Abutment 1: Overview

Vermont Agency of Transportation  
**RECEIVED**  
 CK'D BY \_\_\_\_\_ OK'D BY Rob Young  
 April 21, 2017  
 RESUBMIT NO \_\_\_\_\_ Approved AsNoted  
 BY Rob Young DATE 04/28/2017

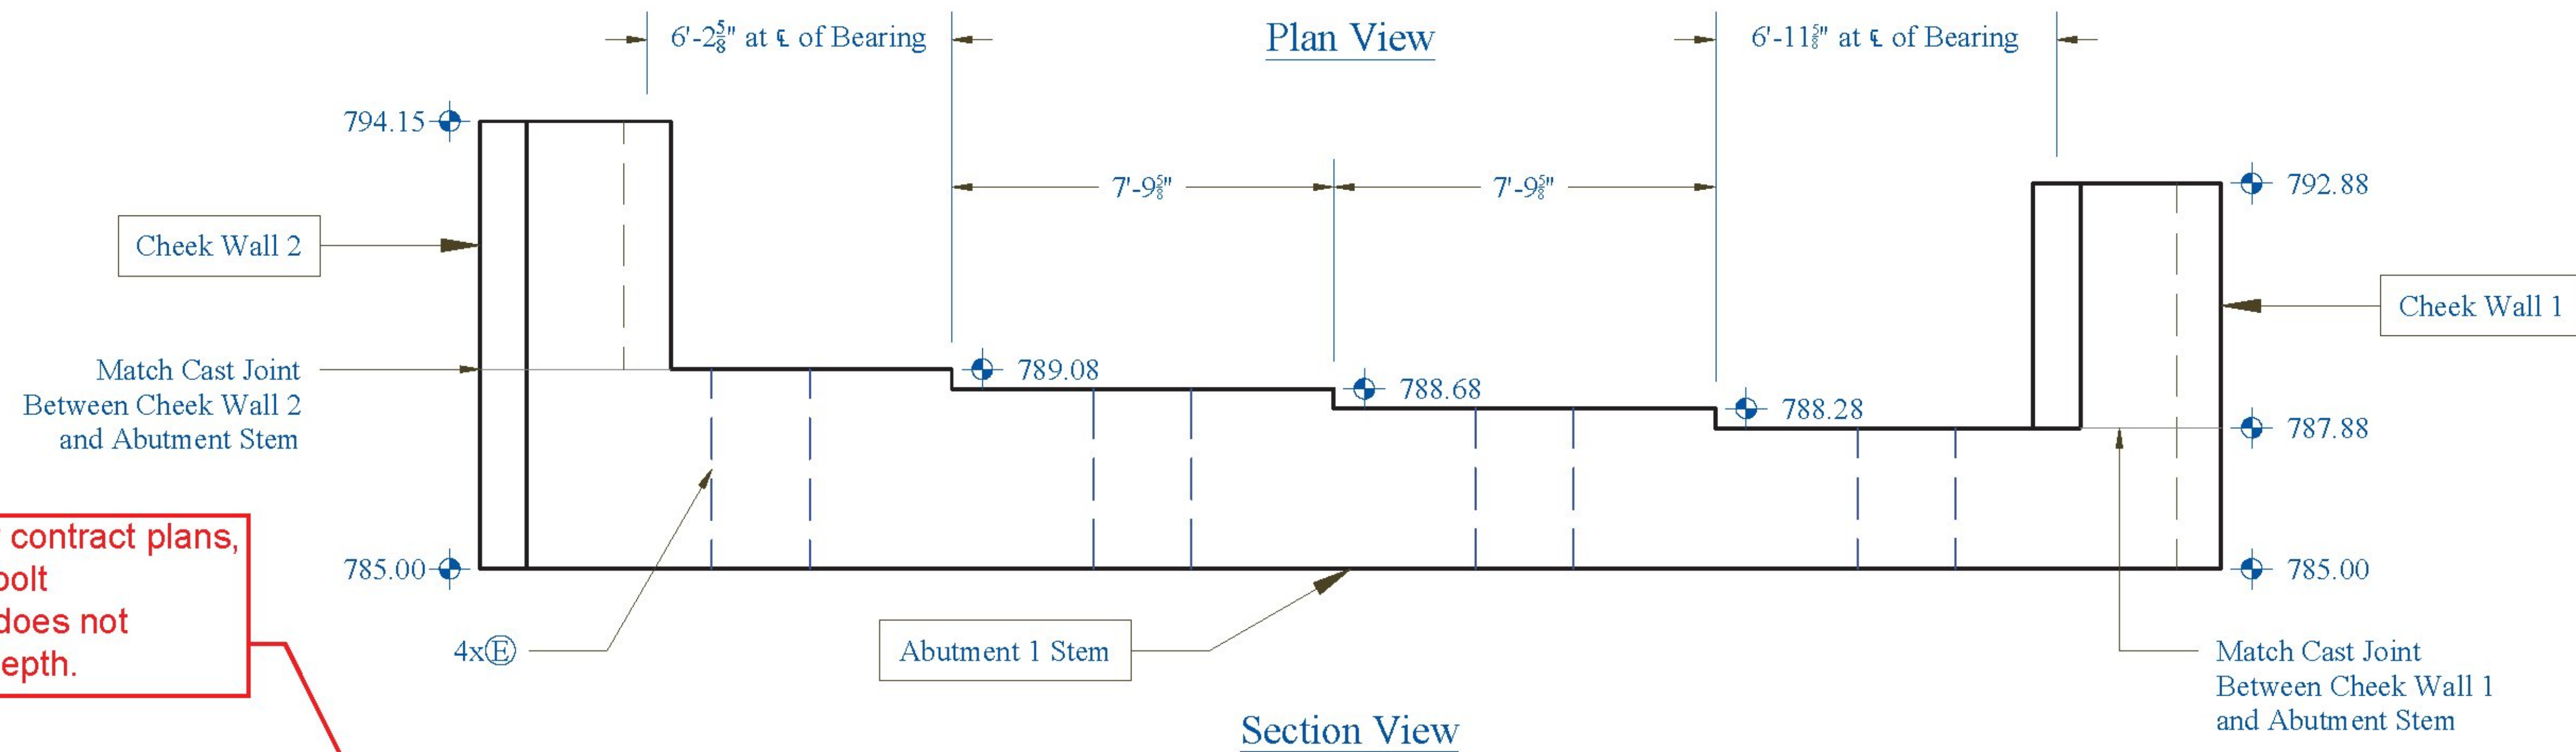
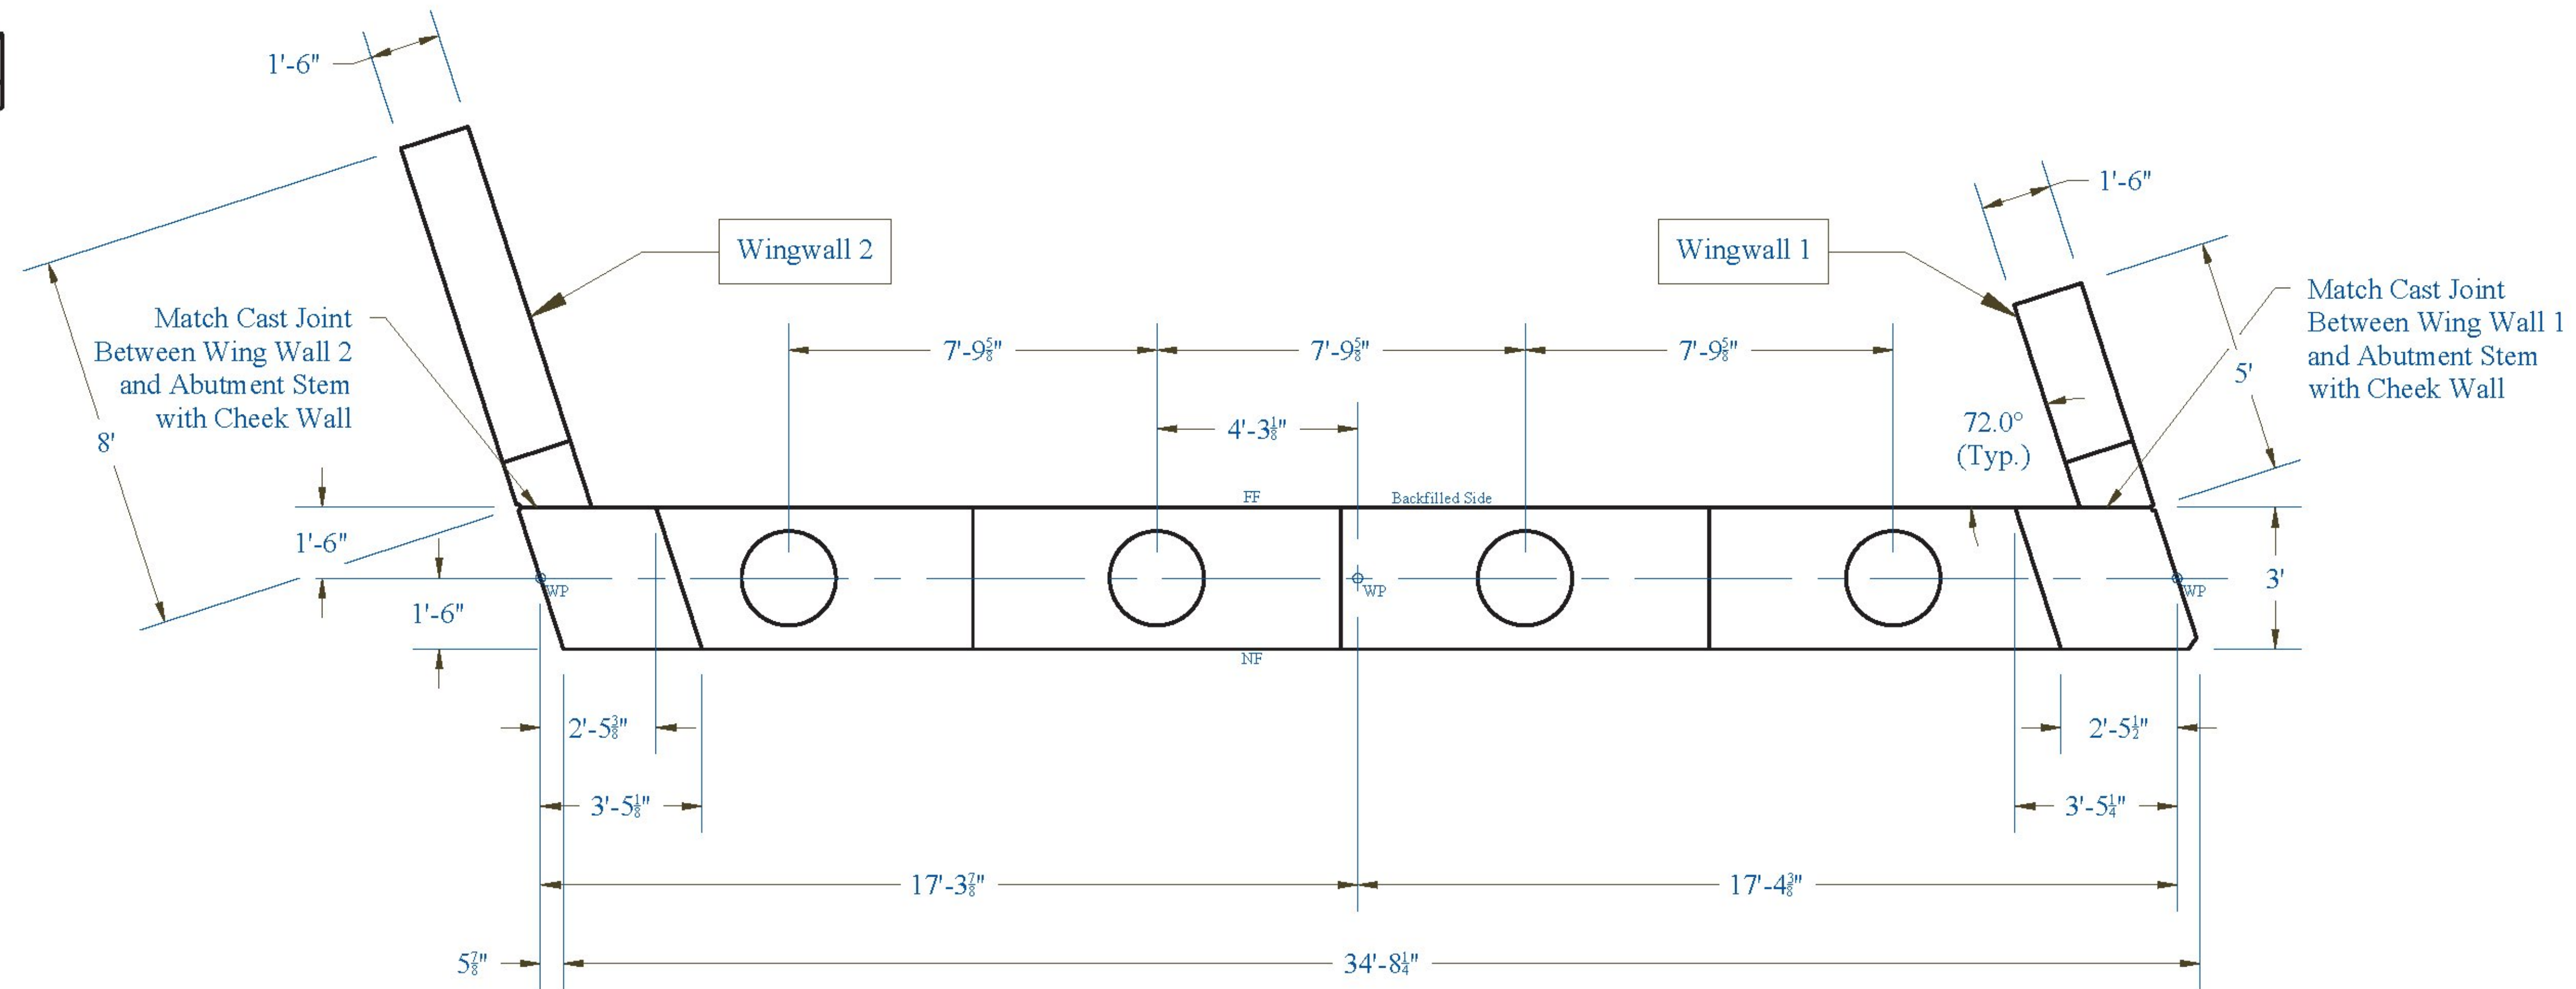
Note that per contract plans, min. anchor bolt embedment does not require this depth.
